This Service Information bulletin supersedes SI B51 02 05 **dated February 2007**.

Squeaking Noise from Door Frame Area While Driving

E60, E61 (5 Series)

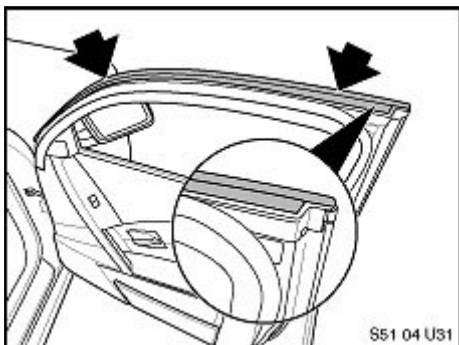
Movement between the flocking material (felt-like material indicated by the arrows) on the upper door seal and the surrounding roof panel may produce squeaking or creaking noises. These noises may be amplified by contamination or cleaner residue on the door opening.

In the case of a customer complaint, refer to the procedure outlined below to replace the seals with improved parts and/or apply the specified transparent Teflon tape.

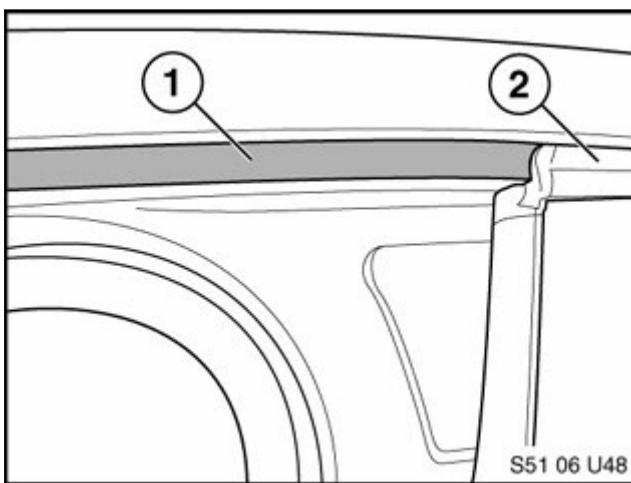
- Thoroughly clean the upper door seal's flocking material, as well as the mating surface on the body of the vehicle with a silicone remover such as 3M General Purpose Adhesive Cleaner or Wurth Silicone Remover.

- Apply a continuous length of Teflon tape (PN 9 407 798) to the contact area of the flocking material (1) on the body of the vehicle.
- The area which the tape should be applied to spans from the middle of the A-pillar to the rear-most point on the rear door opening, as indicated by the arrows.

The tape should be applied slowly and very carefully to avoid trapping air bubbles under the tape. To eliminate visibility of the tape when the door is closed and ensure proper contact with the flocking surface, the upper edge of the tape (1) should line up evenly with the top of the door seal (2) for the entire length of the applied area. The tape should be applied in its full width (16mm) and not be cut down to a narrower width.
